**Re: Aurora State Airport Master Plan Proposed Preferred Alternative  
HDSE Septic Drainfield Correction of the Record and Next Steps Forward**

NV5 and Aron Faegre response to ODA email from Tony Beach dated December 9, 2021 4:20 PM  
concerning HDSE drainfield expansion area at UAO December 20, 2021

SEPTIC DRAIN FIELD IMPROVEMENTS  
AURORA, OR

FIGURE A-1

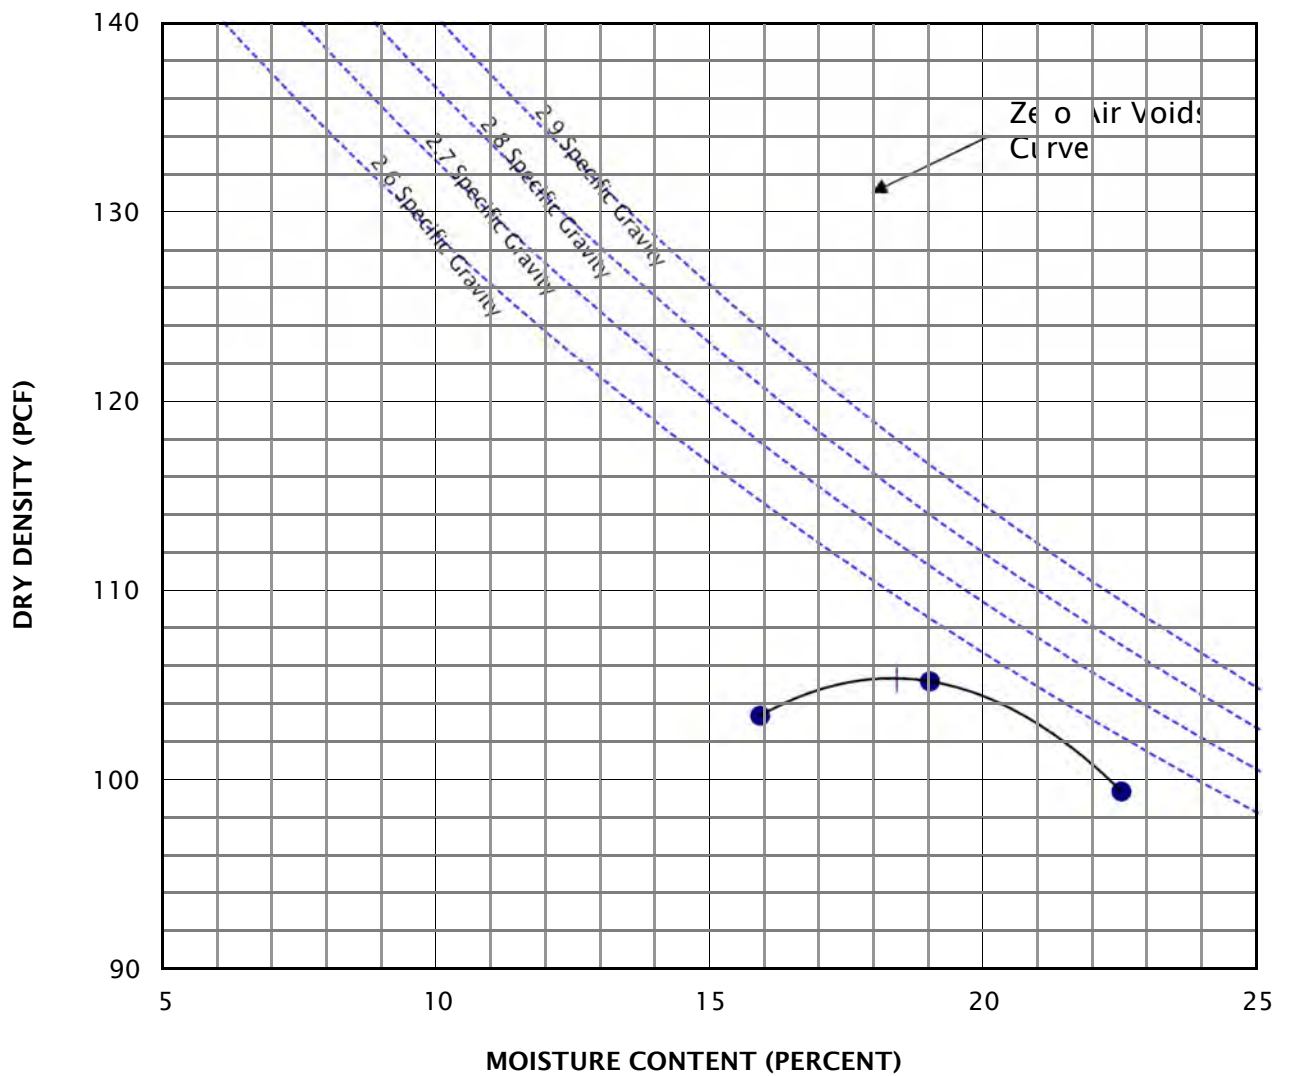
- Report figures
  - o Figure A-1: graphic does not show up in the provided pdf
  - o Figure A-2: graphic does not show up in the provided pdf
- "Such stringent compaction is not permitted in the soil cover of drain fields"
  - o Where does this statement come from?
